<b>Docket Number:</b>	97-AFC-01C
<b>Project Title:</b>	High Desert Power Plant
<b>TN #:</b>	216993
<b>Document Title:</b>	CORRECTED Energy Commission Staff review of CDFW Water Balance Study to correct plot legends.
<b>Description:</b>	This document supersedes TN 216956.
<b>Filer:</b>	AbdelKarim Abulaban
<b>Organization:</b>	California Energy Commission
<b>Submitter Role:</b>	Commission Staff
<b>Submission Date:</b>	4/12/2017 1:13:59 PM
<b>Docketed Date:</b>	4/12/2017

# **CALIFORNIA ENERGY COMMISSION STAFF REVIEW OF CALIFORNIA DEPARTMENT OF FISH AND WILDLIFE'S MOJAVE RIVER ALTO TRANSITION-ZONE WATER BALANCE ANALYSIS**

Abdel-Karim Abulaban, Ph.D., PE, and Paul Marshall, PG, CHG, CEG

**Figure 1 - Comparison between DMC plots when 10,000 AF and 20,000 AF is added to the net water balance**

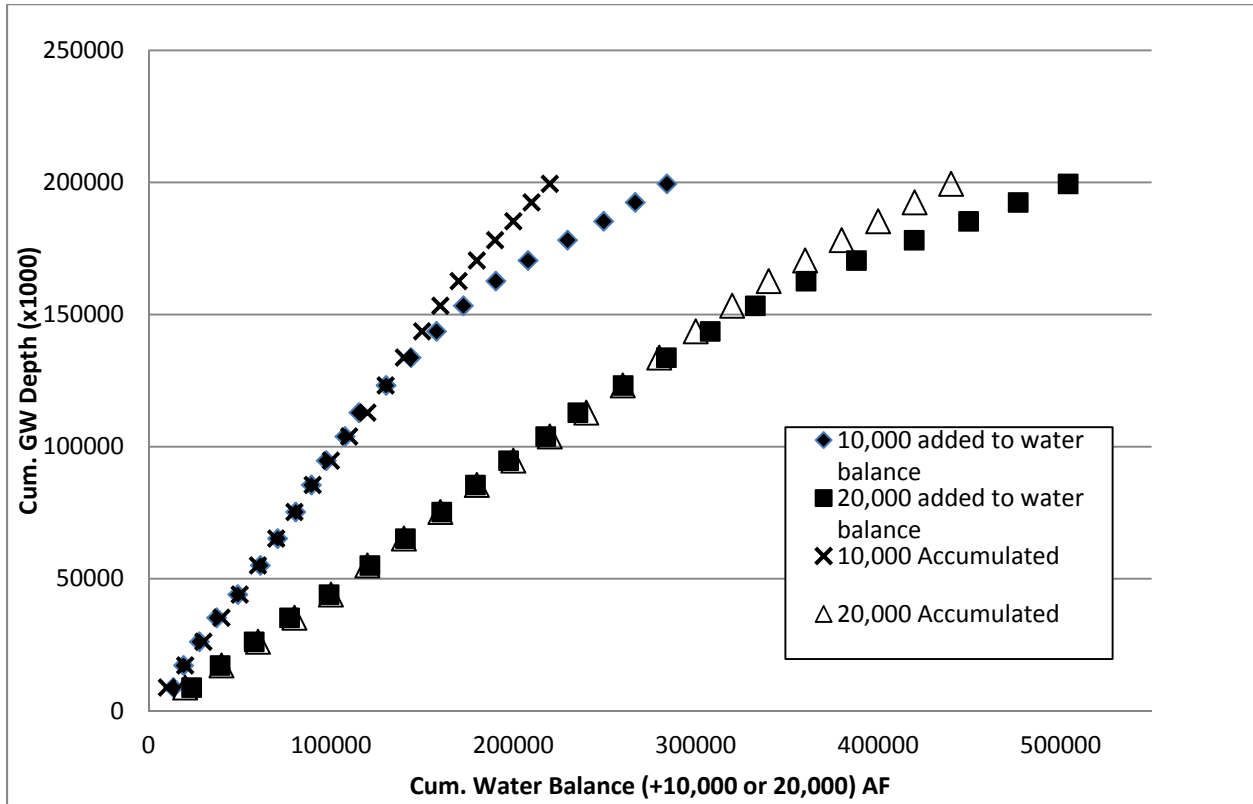
Contrary to what was stated in the water balance study, adding a constant value to either of the variables in a DMC analysis does change the slope of the relationship because the constant added to each value keeps growing as those values are consecutively accumulated. For example, the 10,000 AF added to each water balance value becomes 20,000 AF in the second cumulative sum, 30,000 AF in the third, and so on, up to 220,000 AF in the last sum since there are 22 data points in the record analyzed. To illustrate that adding a constant value to the variables used does affect the slope of the relationship, Staff performed the same analysis done in the water balance study, but added 20,000 AF to each water balance point instead of 10,000 AF, as was done in the CDFW study. A comparison between the plot obtained by Staff and the plot shown in Figure 13A of the water balance study is shown in **Figure 1** below to illustrate Staff's concerns with CDFW's statistical methodology. The relationship between the cumulative values is significantly changed when 20,000 AF was added compared to the case where 10,000 AF was added. By adding the larger value it had the effect of making the relationship more linear and the slope much flatter (almost half the slope of the plot for the DMC analysis in CDFW's water balance study).

**Figure 1** also shows a plot of the added 10,000 AF and 20,000 AF constants accumulated on their own without the accumulated water balance values. As stated above, and as illustrated in **Figure 1**, the reason a more linear plot was obtained when a constant value was added to the water balance data is that the cumulative sums of the actual data are much smaller compared to the cumulative sum of the artificially added constant, such that variations in the actual cumulative sums of the data became too small to be detected by the naked eye. It is clear in the figure that for the most part, the plots of just the sums of the added constants cannot be distinguished from the plots of the cumulative sums of the water balance data with the constants added.

In light of the foregoing, Staff concludes that the results of the DMC analysis presented in the CDFW water balance study are erroneous and cannot be relied upon.

**Figure 2 - DMC plot using winter groundwater elevations and net water balance**

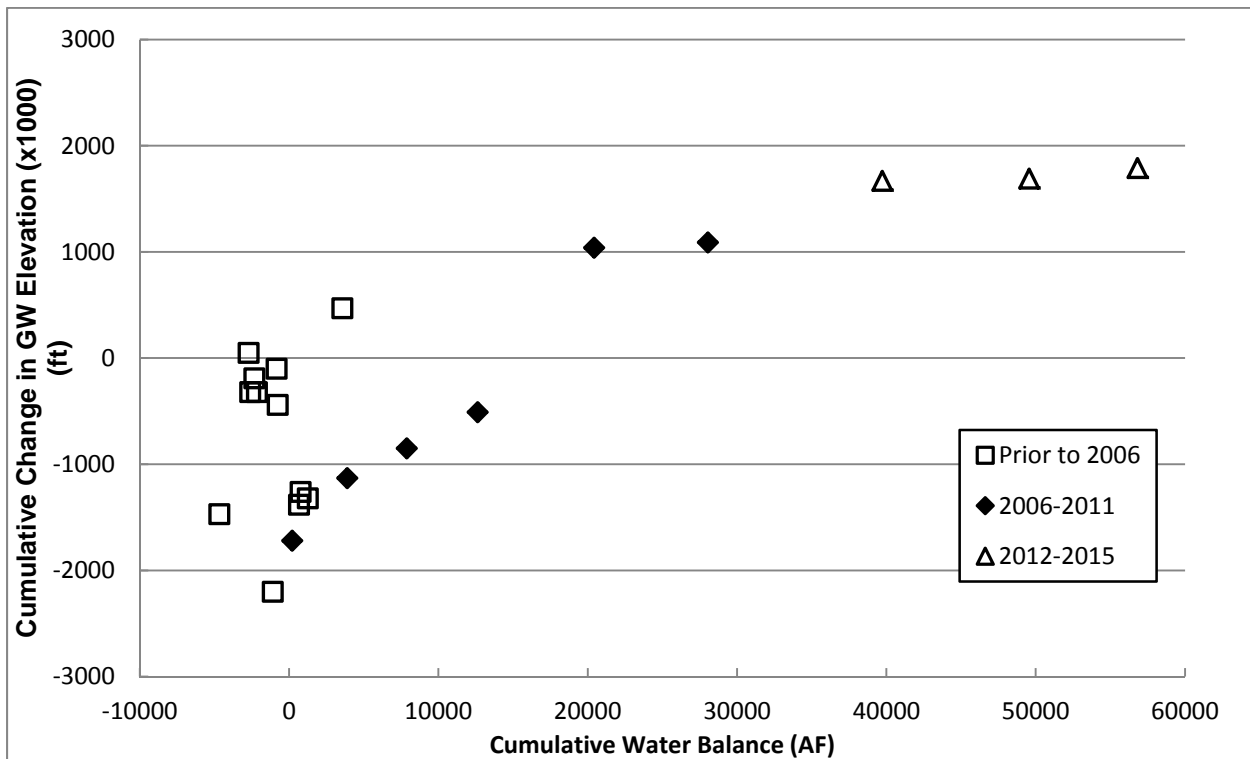
Staff performed an independent analysis using the data given in Table 1A of the CDFW water balance study to determine whether using the appropriate application of the same methods used in the CDFW analysis would show some correlation in the data. In the analysis, Staff used the same data and assumptions as CDFW regarding the major inflow and outflow components for the basin balance described above. Staff performed the DMC analysis on the net water balance against the change in groundwater table elevation. **Figure 2** below shows the DMC plot for the water balance and the change in groundwater table elevation using the winter groundwater elevation data assumed to be caused by the previous year's flows.

Staff also performed the DMC analysis for the net basin balance and the change in groundwater table elevation using the summer groundwater elevation data listed in Table 1B of the CDFW study. The DMC plot for this case is shown in **Figure 3** below. As can be seen from both **Figure 2** and **Figure 3**, the data prior to 2006 do not exhibit any discernible relationship. This is likely due to the assumption that many of the values for the basin balance variables are constant. This also could have been caused by the presence of some inflow or outflow components that have not been accounted for in the CDFW analysis. As discussed above, USGS water resource studies show the gradients between upper and lower aquifers in the TZ change during seasons and at different

Both **Figures 2** and **3** show a pronounced correlation for the data starting in 2006 through 2011. Also, both figures show that the correlation for the data beyond 2011 is not as strong, but still much better than the pre-2006 portion of the plots. The behavior beyond 2011 might have been due to the severe drought period that the state of California experienced. Because of the drought, reliance on groundwater was heavier and resulted in faster declines in water table levels (MWA 2017). Therefore, if the first half of the data are excluded because there is no correlation between the data sets, and if the last part of the graph corresponding to the drought years is ignored because it deviates from the trend exhibited by the middle portion, one is left with the linear portion from 2006 through 2011.

**Figure 3 - DMC plot using summer groundwater elevations and net water balance**

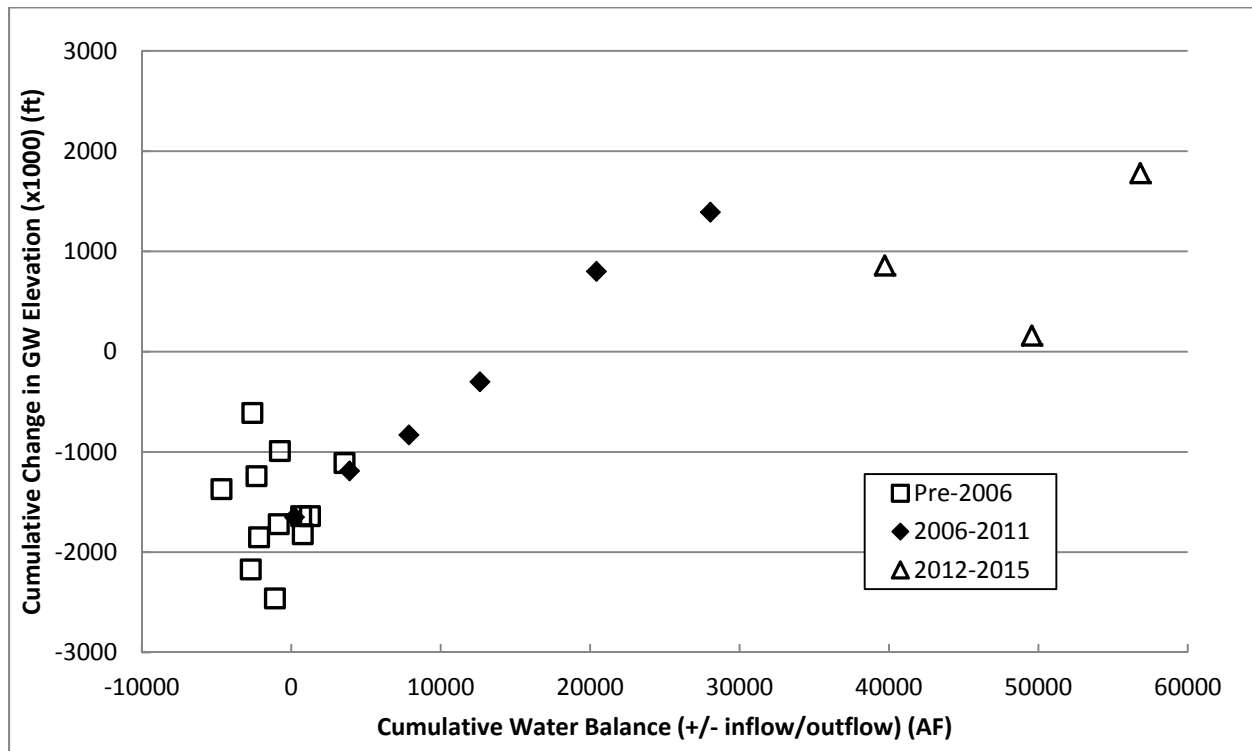
However, this is not supported by the information presented in the CDFW water balance study. For example, **Figure 3**, as well as Figure 8A, shows that the water table has remained below the 7-ft trigger throughout the whole record analyzed. Yet, in a previous submittal by CDFW, it was stated that the TZ vegetation has been improving and the density of the vegetation has been increasing for the most part of the record (CDFW 2016). Additionally, requiring that the groundwater table elevation be maintained above the 5-8 ft. depth below ground surface is in conflict with the adjudication judgment that required the water table in the key well to be no more than 10 ft. below ground surface.

**Figure 4 - DMC plot for winter groundwater elevation changes beyond 2006, with a linear regression fit for data points between 2006 and 2011**

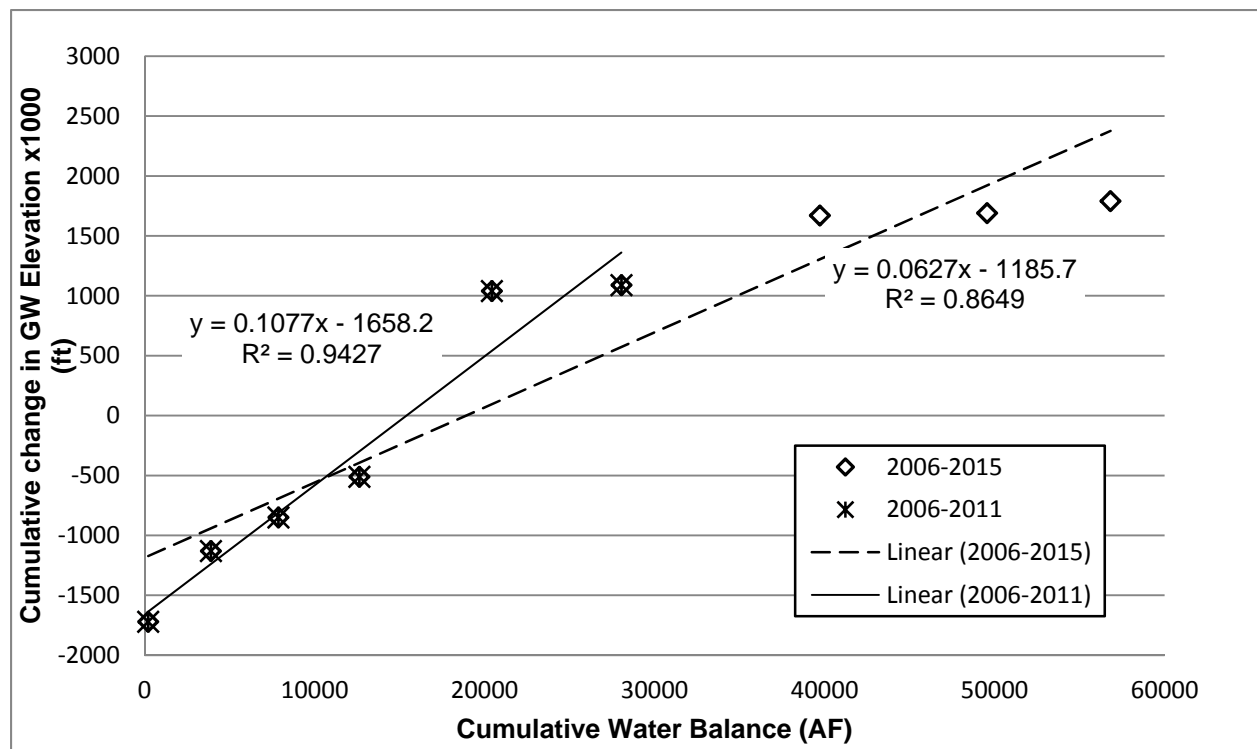
The linear portion of both graphs has been fitted with a linear regression line as shown in **Figures 4** and **5**. The coefficient of determination was 0.94 for the plot using winter groundwater elevation changes, and 0.99 for the one using the summer water elevations. Both coefficients of determination indicate a very good fit between the data and the fitted linear relationship.

Both of the fitted regression lines have very close slopes of about 0.11. The slope indicates that withdrawal of 1,000 acre-feet from the TZ results in 0.11 ft. of groundwater table drawdown, or 9,000 acre-feet for a 1-ft drop in the water table elevation. The fact that the linear portions of both graphs were fitted with two lines having very similar slopes gives confidence that this may be closer to the true relationship for the data analyzed, given all the questionable assumptions about the components of the water balance equation.

Using the slope of the fitted linear regression lines, Staff concludes that diversion of 3,000 AFY or so of recycled water for HDPP might cause a fraction of a foot (0.33 ft) of a drop in the water table. It can be said with confidence that this is within the margin of error of the input data, whether they were individually measured or due to the assumptions that several of the major water balance components were assumed constant throughout the 22 years used in the analysis. Staff also understands that use of such a small data set may not demonstrate significant statistical significance. Overall the data set suggest there is no significant linear relationship between changes in groundwater elevation and the net basin balance. Using a simple linear regression is not appropriate for this data. The groundwater system in the TZ appears to be complex and changes in groundwater elevation are likely governed by non-linear relationships. Also, use of fixed value assumptions for many important variables in the basin balance is likely not appropriate for anything other than the simple basin accounting system used for the groundwater basin adjudication for which it was designed.
